10/561,468

Office Action Summary

DETAILED ACTION

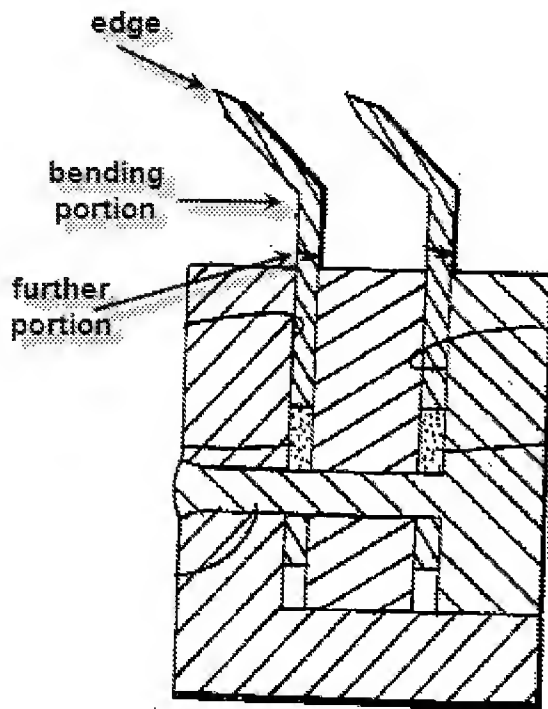
With respect to claim 1, Emmett discloses a razor head (it is old and well known in the art for a razor blades to be supported in a razor head) having one or more fixed bridge partitions (see figure 8) and at least one razor blade (302) attached to a corresponding fixed bridge partition of substantially equal length (see figure 8), each

blade comprising an edge portion with a cutting edge (306), a bending portion (see figure 8, below) positioned between the edge and the further portions, where the edge portion is bent relative to the further portion (see figures 7 and 8) and spaced from said cutting edge and the fixed bridge partition (see figure 8).

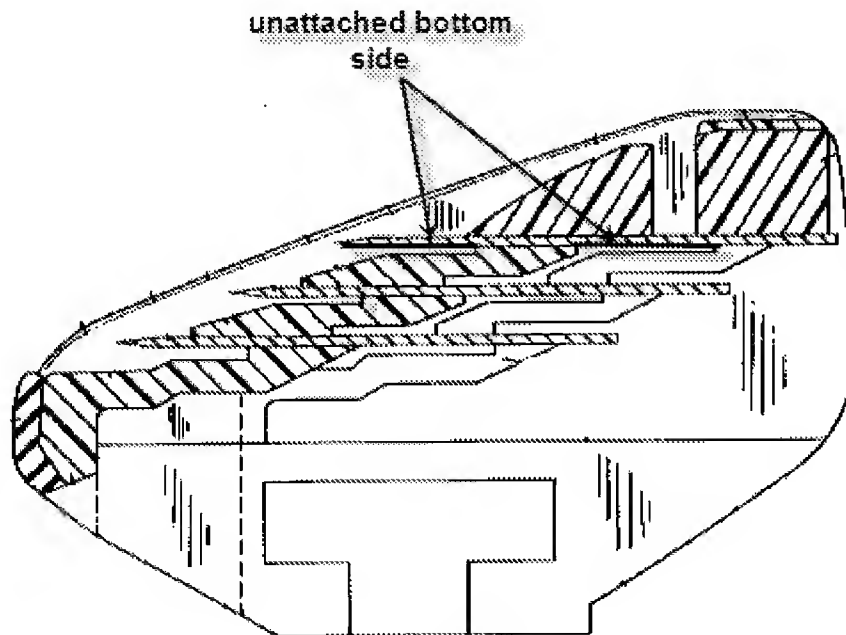
Ferraro discloses a top side of a blade (Fig. 3, 40,50,60) attached to a bridge partition (Fig. 3, 80,80a) of a razor head, and an unattached bottom side (Fig. 3, see below). It would have been obvious to one having ordinary skill in the art at the time of invention to provide Emmett with a bridge partition as taught by Ferraro. It is old and well known to provide a bridge partition between blade members of a razor head to provide additional structural support. The bridge partition is also capable of serving as a protective guard as the blade engages the skin, creating a smoother shaving process.
